Access Compliance Report Public Rights-of-Way (Curb Ramps)

Main Street: ISLAND_WAY		Cross Street: DANA_POINT_HARBOR_DR		Location:	W
ADA ID: RPRK220208172915	Ramp Type:Type 1 - Perpendicular	Initial Pass/Fail: Fail	Overall Compliance: No	Severity Score:	16

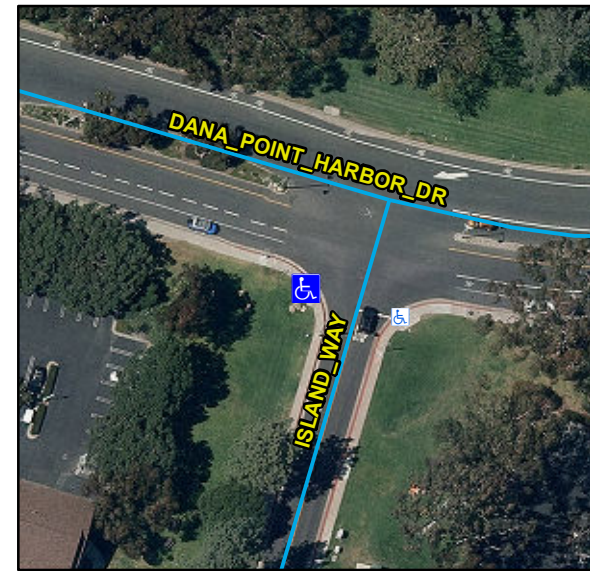
R204.3, R304.2.2, R304.5.3, STD 1115

Remove & Replace Entire Ramp.
